REQUEST FOR PROPOSAL

Project Title: Cooley Laboratory Renovation
Location: Montana State University

PPA No.: 10-0023
RFP No.: 60 r
Date: July 23, 2012

SWITCH FUNCTION OF LOUVER L-6 and L-5

**① PARTIAL BASEMENT MECHANICAL PLAN (WEST)**  
 1/4"=1'-0"

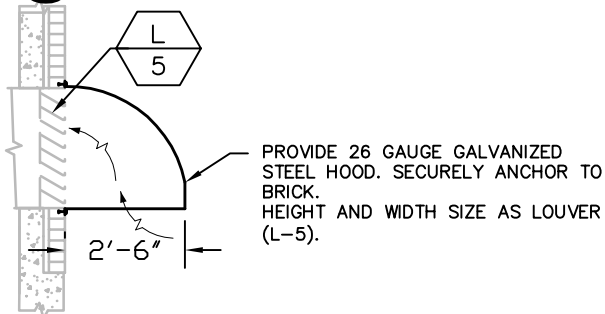
- Revise the components shown to serve L-6 to the L-5 Location
1. Supply Fan SF005 locate @L5
2. Booster Coil BC005 locate@ L5
3. L5 - EF locate @ L6 location
Revise WH-1 & WH-2 exhaust per detail 2 on CM-15
Revise Natural Gas Vent per Detail 4 on CM-15
Add Air Intake hood per Detail 2 @ L5 shown on CM-15

**④ NATURAL GAS VENT PIPE ELEVATION DETAIL**  
 NO SCALE

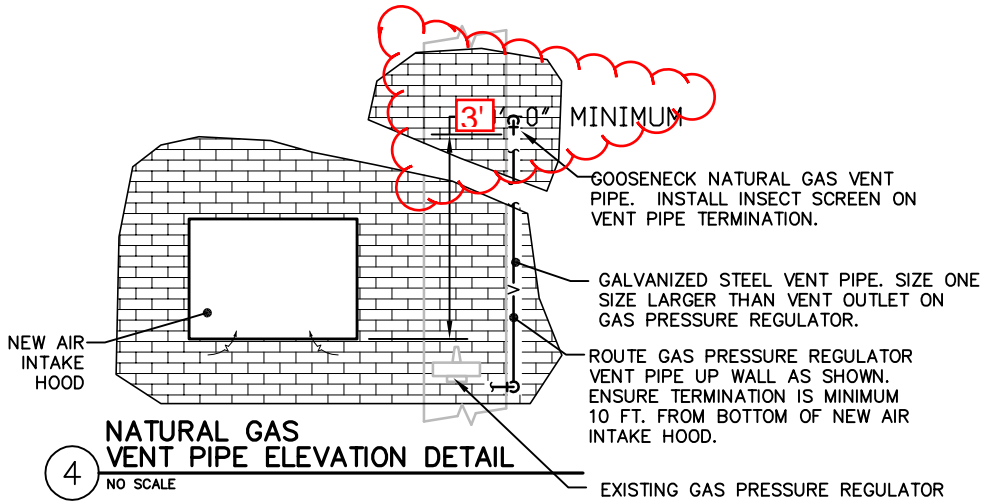
Don, I just found out from the mechanical official how they interpret the required separation for the gas regulator vent. If it is OK for the vent to terminate the vent line in detail 4, sheet CM-15 at 3' above the intake rather than 10 feet. Do you want me to issue a revised drawing?

NOTE:  
 ① GALVANIZED STEEL NATURAL GAS VENT PIPE. SIZE ONE SIZE LARGER THAN VENT PIPE OUTLET ON REGULATOR.
